ARRL Handbook CD

Title: 13.8-V, 40-A Power Supply

Topic: A 13.8-V, 40-A Switching Power Supply

Also included is an updated version of figure 11.37, the schematic diagram for the 13.8-V, 40-A switching power supply.

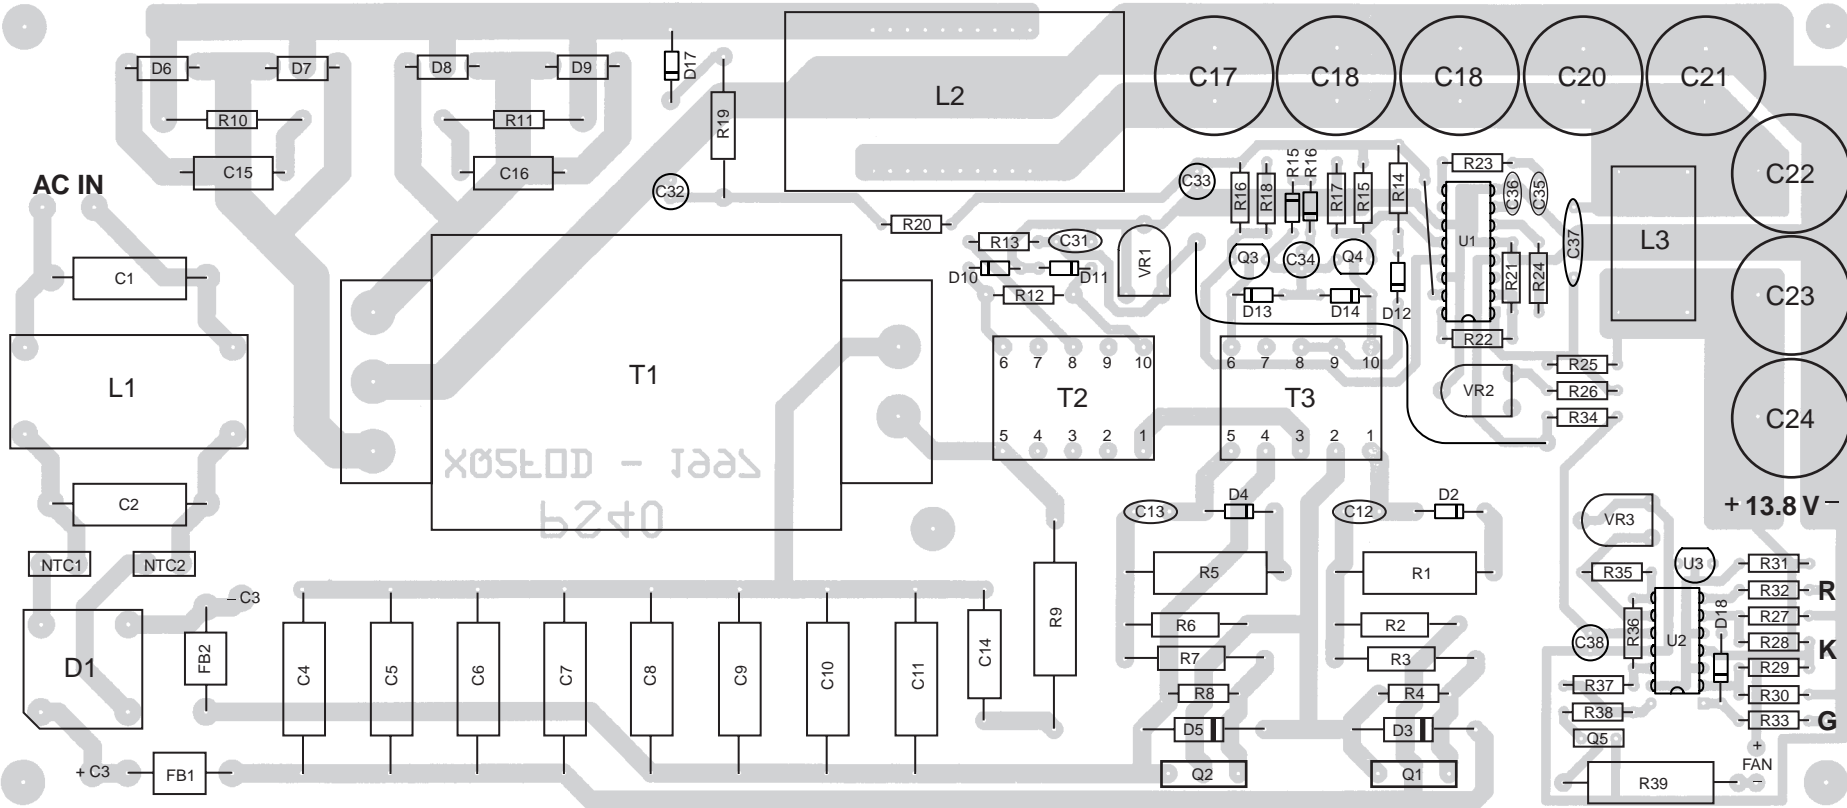
The values for R2, R6 and R36 are shown incorrectly on page 11.30 of the Handbook. Also, the resistor labeled R7 near U2B should be labeled R31.
